### **Written submission from the Athabasca Chipewyan First Nation**

#### **Orano Canada Inc., Cluff Lake Project**

Request to Revoke the Current Licence and  
Release the Cluff Lake Project to the  
Institutional Control Program

# Technical Review of Orano Canada Inc.'s Cluff Lake Project Long-Term Monitoring and Maintenance Plan, Orano Canada Inc Response

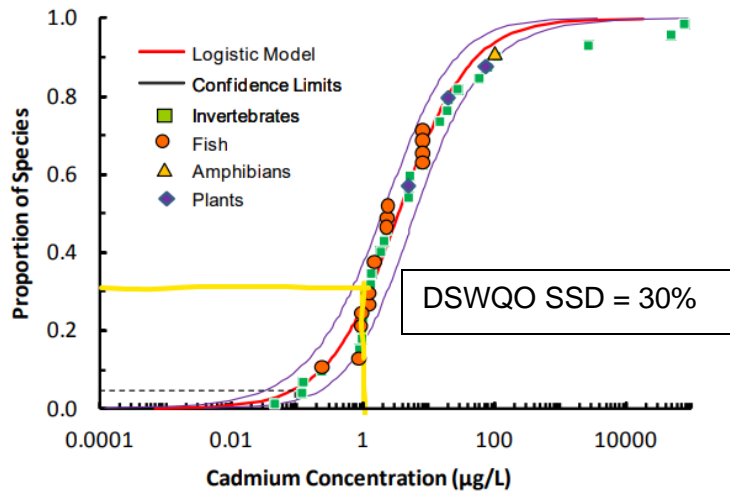
- Arsenic: Carcinogenicity is the health protection endpoint for drinking water quality guidelines (10 ug/L; Health Canada 2021) but adverse effects have been observed to dermal, vascular, and neurological systems from elevated exposures. The DSWQO is 5 times the Health Canada (2021) guideline (50 ug/L) and ~275 times higher than the safe exposure level (0.18 ug/L) set by the US EPA for protection of people consuming water and aquatic organisms (fish, plants), which is even lower if the increased consumption of traditional foods and medicines by ACFN members is considered (0.03 ug/L). The predicted concentrations of arsenic in all surface water bodies impacted by contaminated groundwater from the decommissioned Cluff Mine Site are higher than the established health risk guidelines indicating potential risks of carcinogenicity and other systemic effects.

- Cadmium: Similar to uranium, the primary health effect observed from elevated exposure to cadmium is nephrotoxicity. This indicates a potential increased risk from additive or synergistic effects from exposure to multiple COPCs which target the kidneys. This has not been accounted for in the LTMMP. While the predicted concentrations of cadmium in waterbodies within the Cluff and Island Creek watersheds are below Health Canada guidelines (7 ug/L) it is unclear if this guideline is protective given the potential for additive effects from exposure to the complex mixture of COPCs reaching surface water from contaminated

groundwater. attributed to the decommissioned Cluff Lake Mine site. Similar to arsenic, when accounting for potentially higher exposure of ACFN members from consumption of aquatic biota in traditional diets to derive a WQCIU (0.002 ug/L), a higher potential for adverse health risks is indicated by predicted concentrations of arsenic.

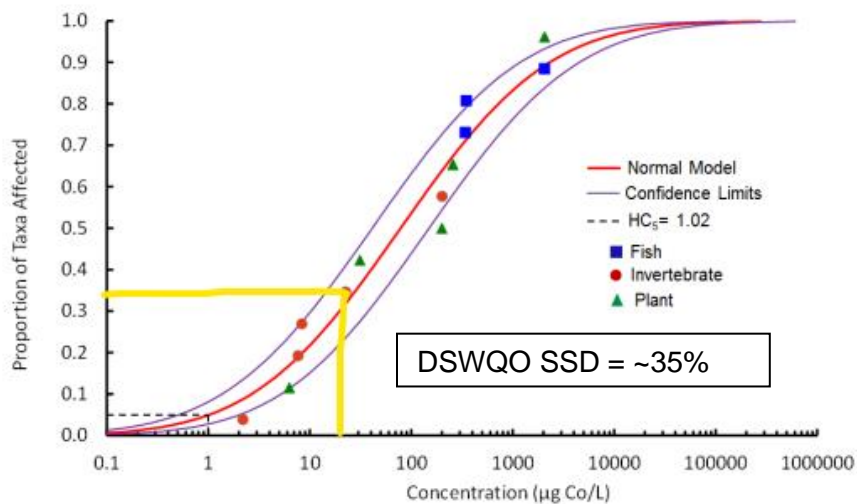
- Cadmium: The long-term surface water quality guideline was established to protect 95% of aquatic biota (0.09 ug/L SSD 5<sup>th</sup> percentile) using available toxicity data which reports feeding inhibition in *D. magna* as the most sensitive endpoint and species. The toxicity data also indicate that aquatic invertebrates are the most sensitive taxa followed by fish, plants/ algae, and amphibians (CCME, 2014). The DSWQO (1 ug/L) is ~ 10 times higher than the published guideline (0.08 ug/L; calculated using CCME equation and 44 mg/L hardness), indicating there is lowered health protection for aquatic biota managed under the DSWQO and the potential for adverse effects on the survival, growth, and reproduction of fish and invertebrates inhabiting Island Lake (1.3 ug/L), Claude Lake (0.47 ug/L) and Claude Creek (0.5 ug/L). These water bodies are predicted to exhibit elevated concentrations of cadmium as a result of contaminated groundwater at the decommissioned Cluff Lake site reaching these waterbodies. The figure below, modified from CCME (Figure 2; 2014), shows the difference in protection level, 95% are protected under the federal guideline (dashed line) compared to 70% (yellow line) with the DSWQO.

- Cobalt: Similar to cadmium, toxicity is hardness dependent, the long-term federal environmental quality guideline was established to protect the majority of species and endpoints using the 5<sup>th</sup> percentile SSD approach and aquatic invertebrate are the most sensitive species studies to date (Environment Canada, 2017) but the sensitivities of various taxa differ, with plants/algae reported as more sensitive to cobalt than fish (Table 2; GOC 2017. Again, the DSWQO established in the LTMMMP is much higher than the hardness adjusted (44 mg/L) FEQG (20 ug/l compared to 0.73 ug/L) indicating a lower degree of protection in Claude Lake (5.4 ug/L), Claude Creek (18 ug/L), Peter River (1.7 ug/L), and Cluff Lake (0.98 ug/L). These water bodies are predicted to be impacted by cobalt in groundwater migrating off the decommissioned Cluff Mine site. The figure below adapted from GOC (Figure 1;2017) illustrates the difference in protection of aquatic biota in waterbodies monitored and managed under the DSWQO.
